SERVICE BULLETIN

ENGINE CONTROLS - POWER CONTROLS - Rework Electronic Control Unit (ECU), PN 2119576-1011 to PN 2119576-1013, or Install ECU PN 2119576-1013 on the AS907-1-1A Engine Model

ATA Number AS907-76-9031 (Publication Number D202101001575)

Figure 1. ECU Nameplate

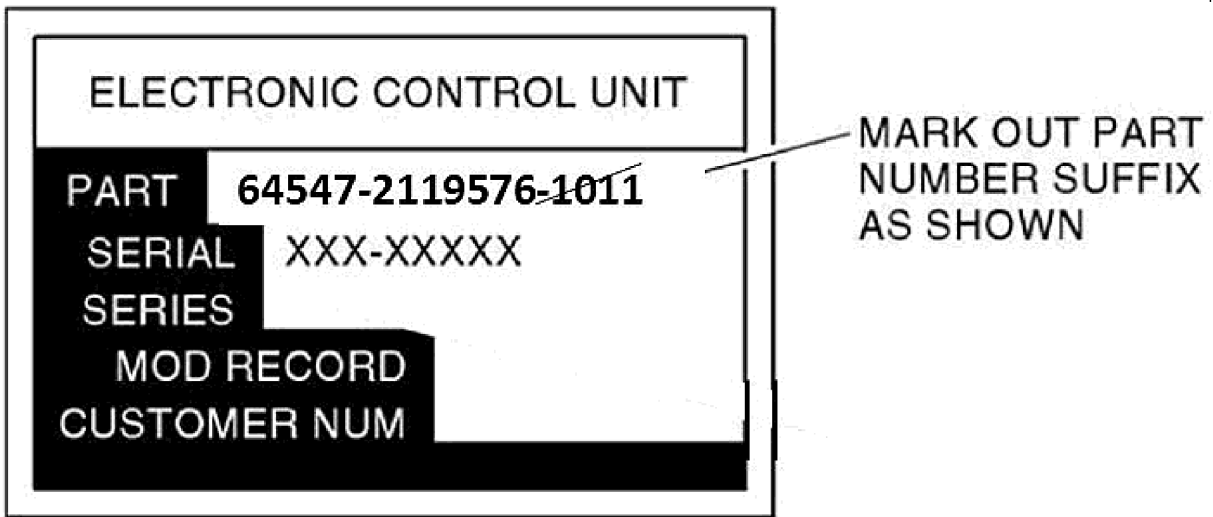
NOTE: If the ECU was originally manufactured as PN 2119576-1011 ensure the ECU part number suffix is marked out on the ECU nameplate. Refer to [Figure 1](#).

NOTE: Make sure there are no inappropriate engine-related CAS messages or faults on either the EICAS or the MDC.
- (18) Re-identify each reprogrammed ECU PN 2119576-1011 using supplemental label, PN 4244228-1050, as specified in Software Download Procedure PN SW4208026-1003 Rev A, 12 June 2020.

Figure 2. ECU Nameplate

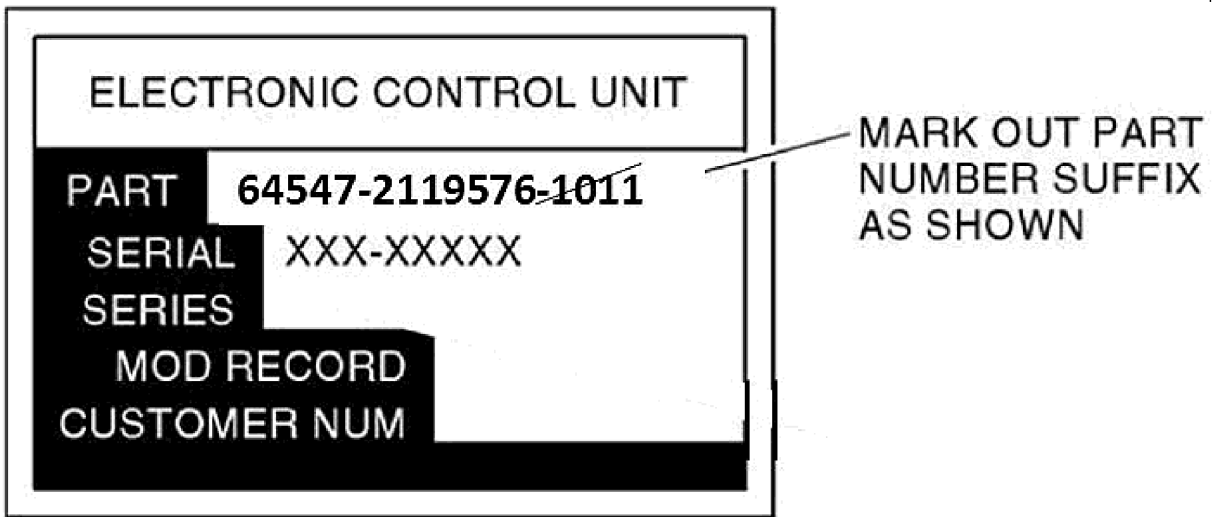
- NOTE: If the ECU was originally manufactured as PN 2119576-1011 ensure the ECU part number suffix is marked out on the ECU nameplate. Refer to [Figure 2](#).
